**SUPPLEMENTAL MATERIALS OF PREMIER REAL  
ESTATE SERVICES II, LLC, FOR SITE PLAN  
APPROVAL, 41 RENTAL APARTMENT HOMES UNDER  
C.G.S. § 8-30g, 103 LOUIS STREET, NEWINGTON, CT**

**Newington Town Plan and Zoning Commission  
January 26, 2026**

Re: Responses to Town Planning and Engineering Department's  
January 11, 2026 Application Comments

# Natural Diversity Data Base

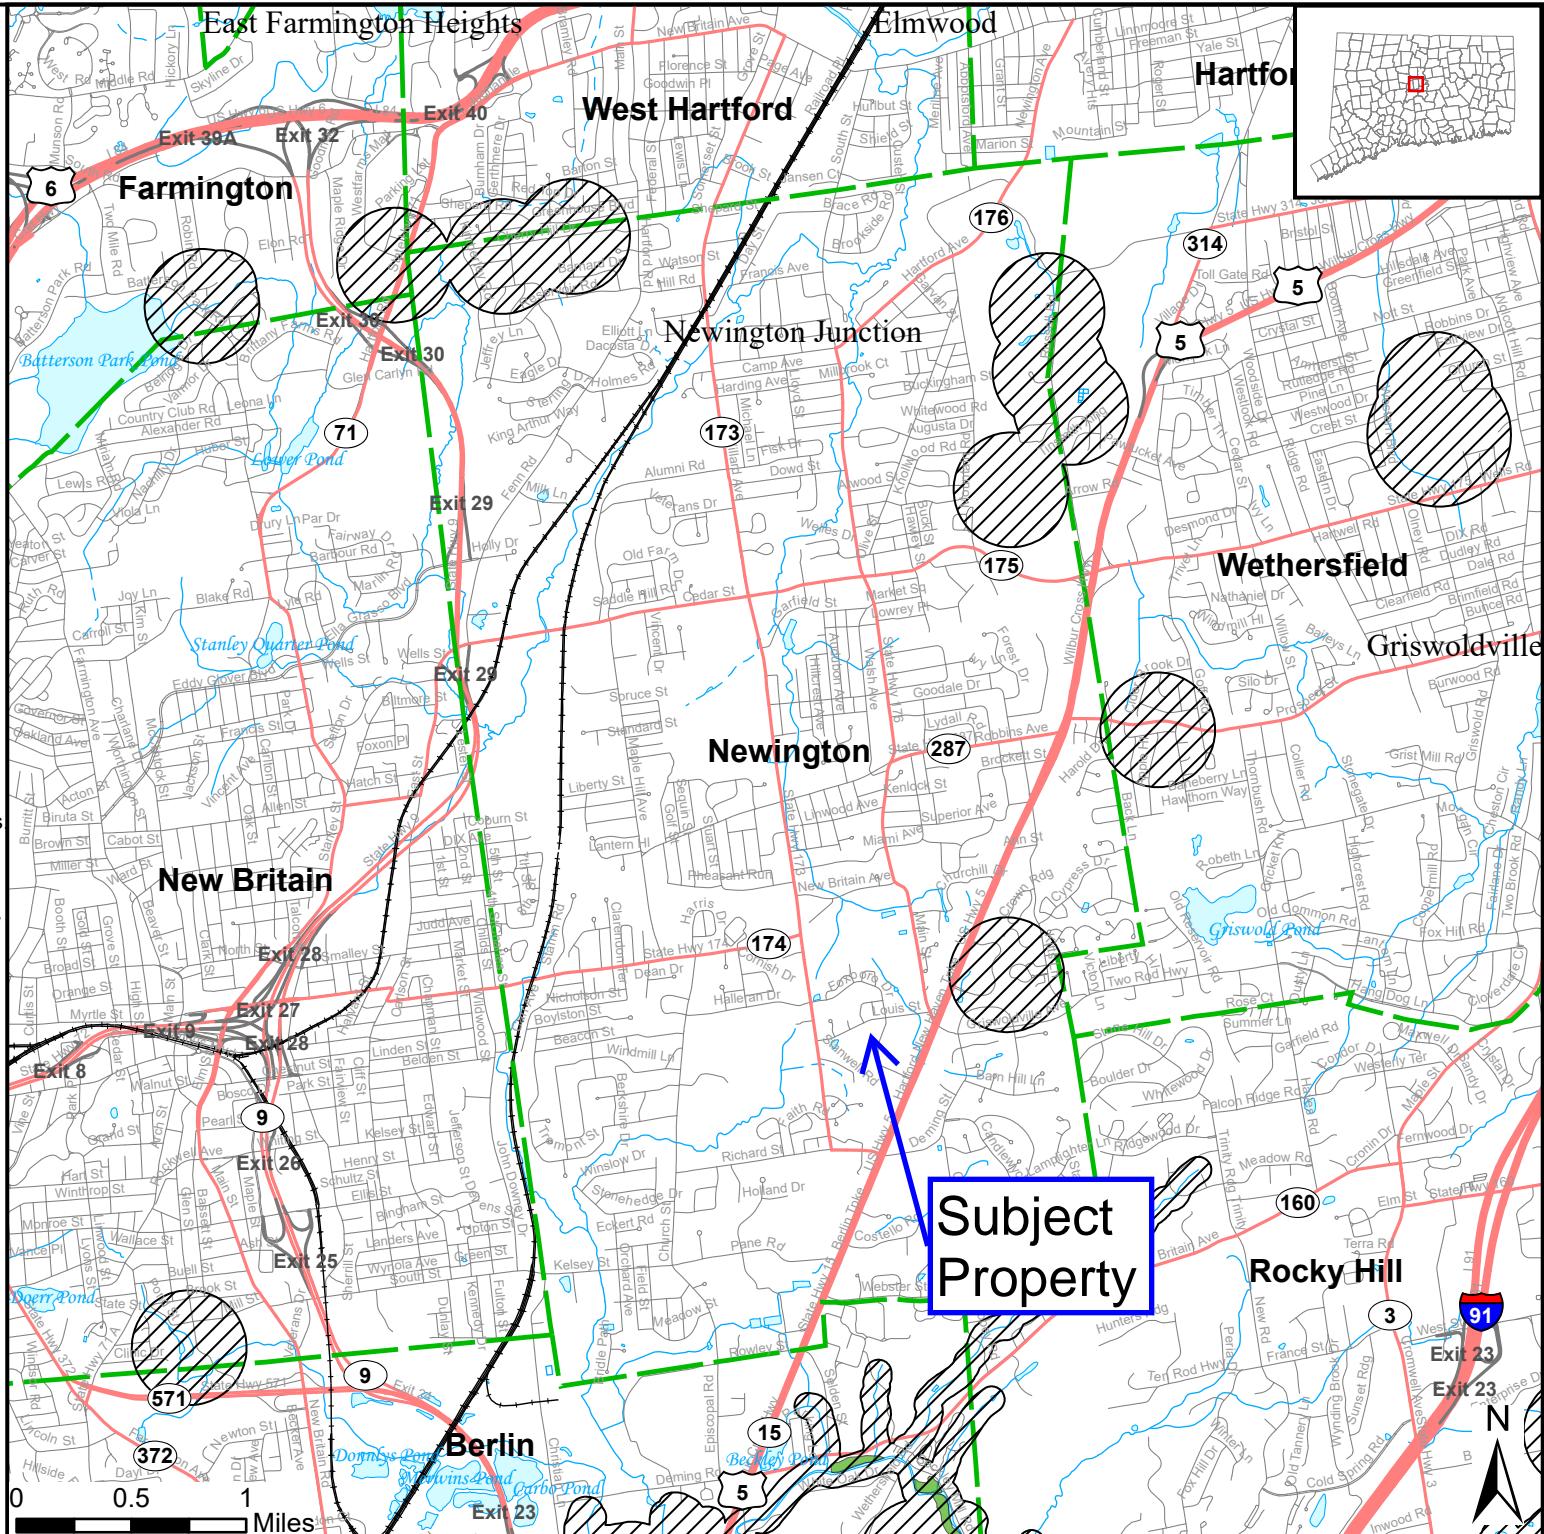
- a. Add note that the property has been reviewed for NDDB and indicate if any species are or are not present. (NZR 5.3.4.1.F)*

**RESPONSE: The subject property is not in an area identified by the CT NDDB map as possible habitat for listed, endangered, threatened, and special concern**

species. A copy of the CT NDDB map, showing the applicant's property, is included in its supplemental materials. The applicant however agrees, as a condition of approval, to amend its application consistent with the above comment.

**ISD-1**

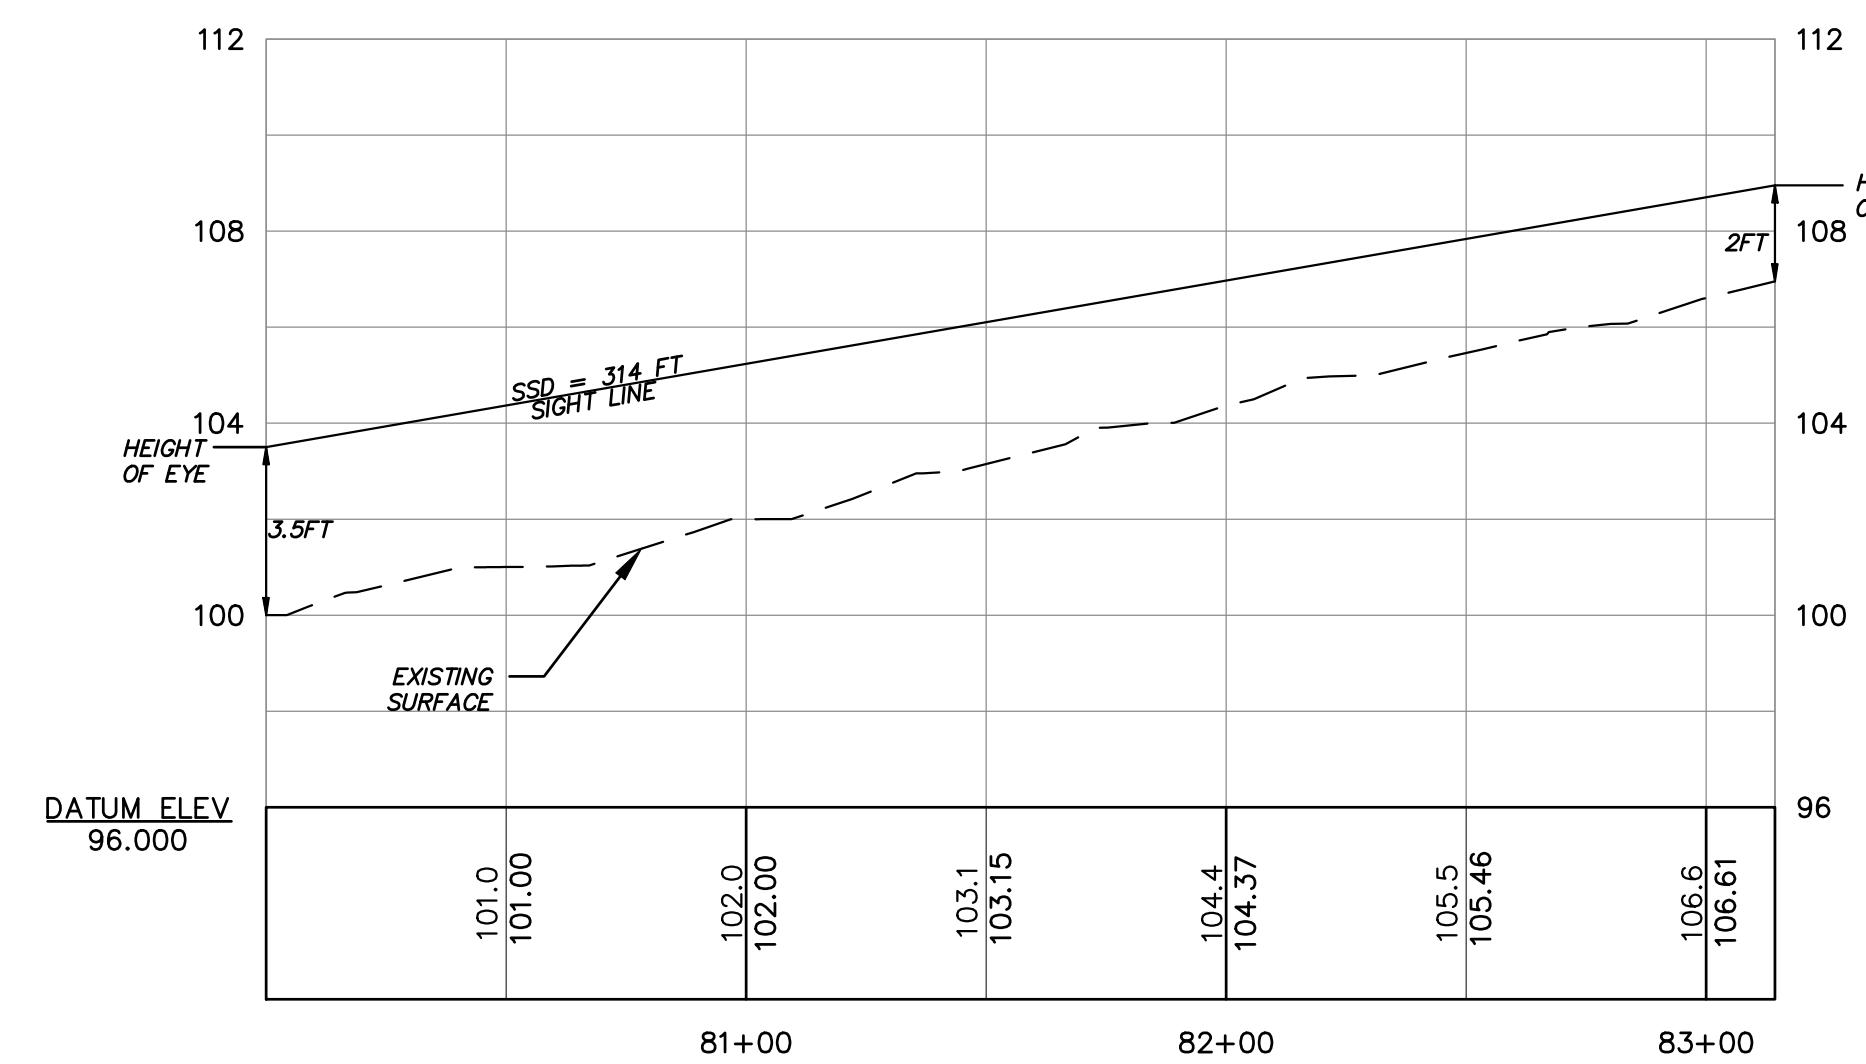
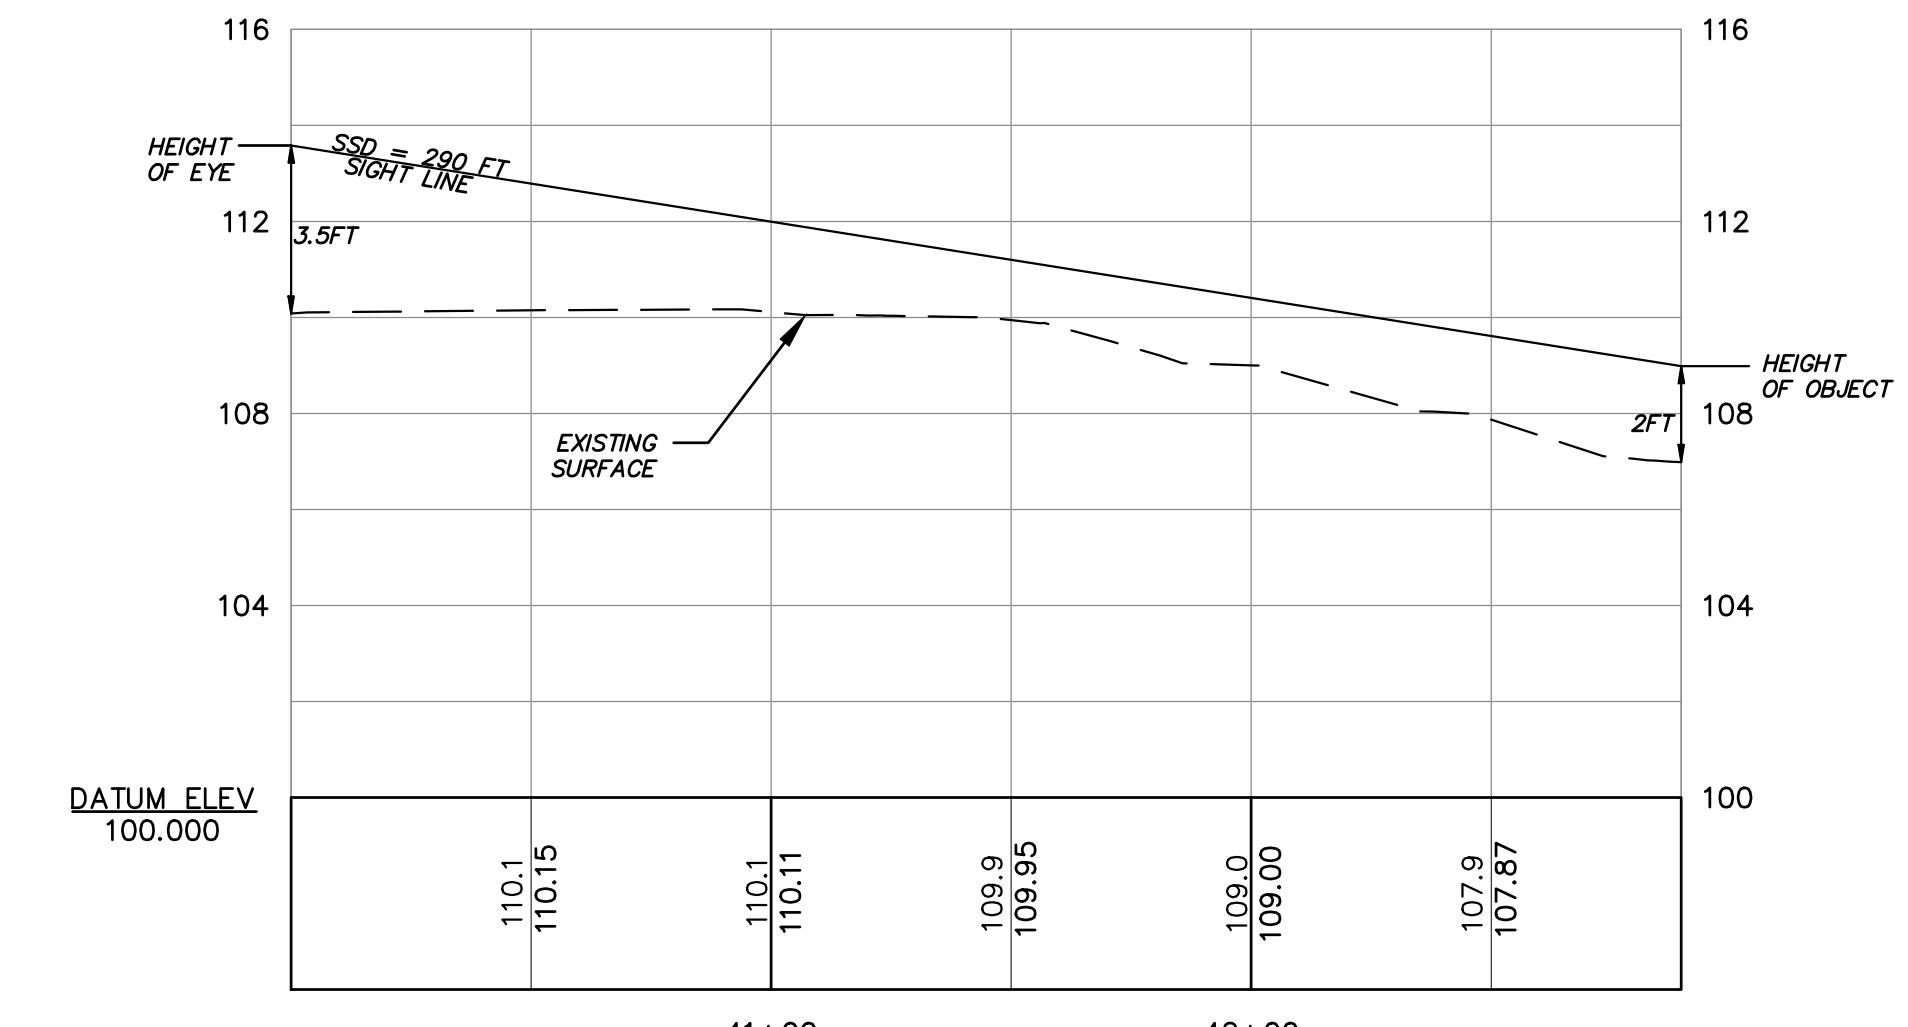
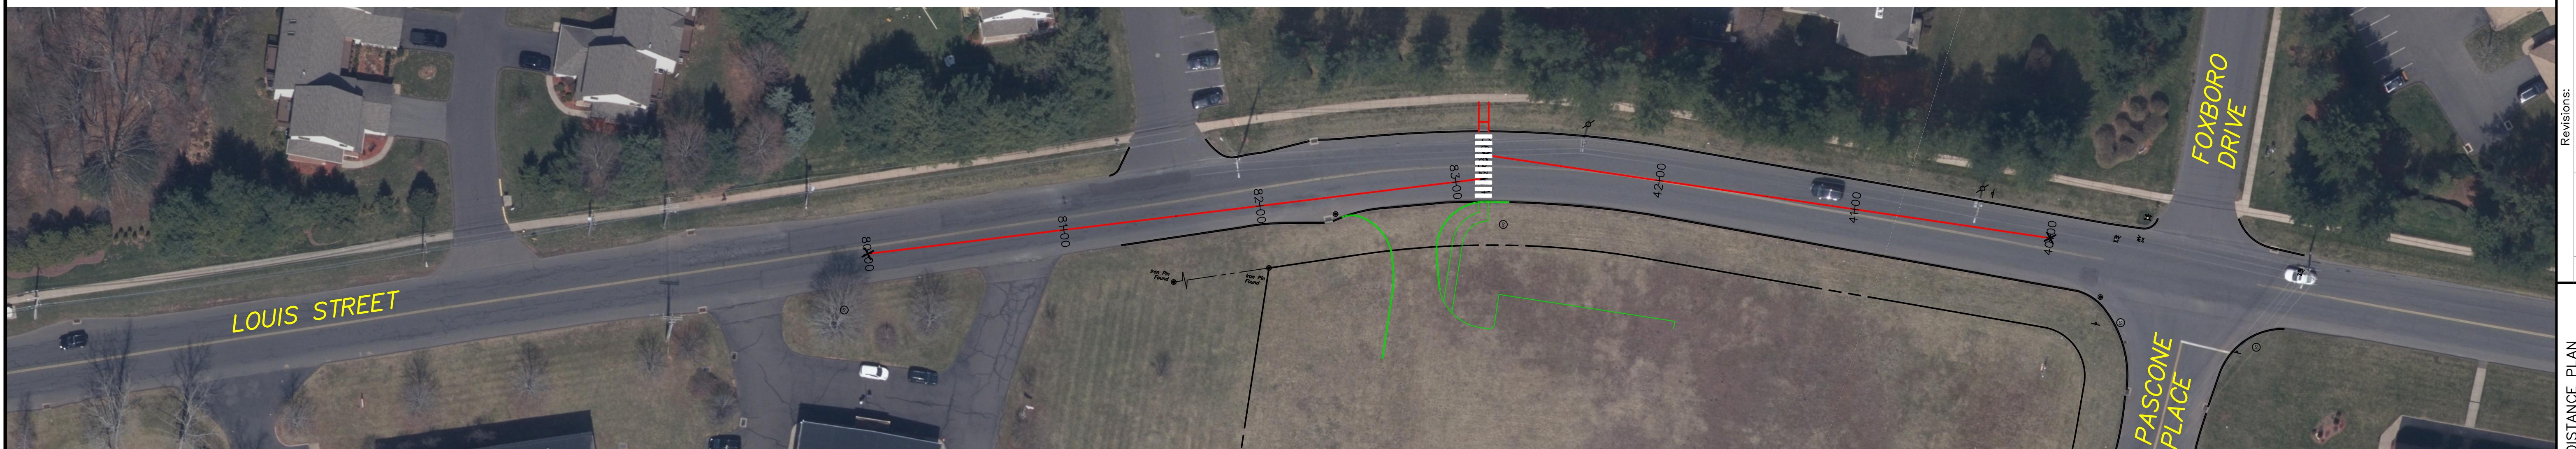
- a. *Show available and required sight lines for ISD and SSD on the site plan (Traffic Report).*

- a. *The traffic report includes the available sight distances and states that "The available sight distances meet the current ConnDOT criteria for an approach speed of 40 miles per hour." Please include the calculated minimum required Stopping*

*Sight Distance and Intersection Sight Distance for cars traveling on Louis Street and Pascone Place and exiting the site driveways in the report. In addition, speed data is not presented for Pascone Place and information on the 85% percentile speed should be included for the calculated sight and stopping distances.*

**RESPONSE:** The applicant has included in its supplemental materials a plan and profile sheets showing the minimum required Intersection Sight Distance (ISD) and minimum required Stopping Sight Distances (SSD) for the driveway.

**RESPONSE:** A speed count was conducted on Louis Street April 14<sup>th</sup> through April 21<sup>st</sup> 2015. A copy of the count is included in the appendix of the original report. The measured 85% speeds were 37 mph and 40 mph for the eastbound and westbound directions, respectively. Based on Table 11-2C, the minimum required ISD for 40 mph is 445 feet. The minimum required SSD, based on Table 7-1A, is 305 feet on level ground and 315 feet on a 3% downgrade.
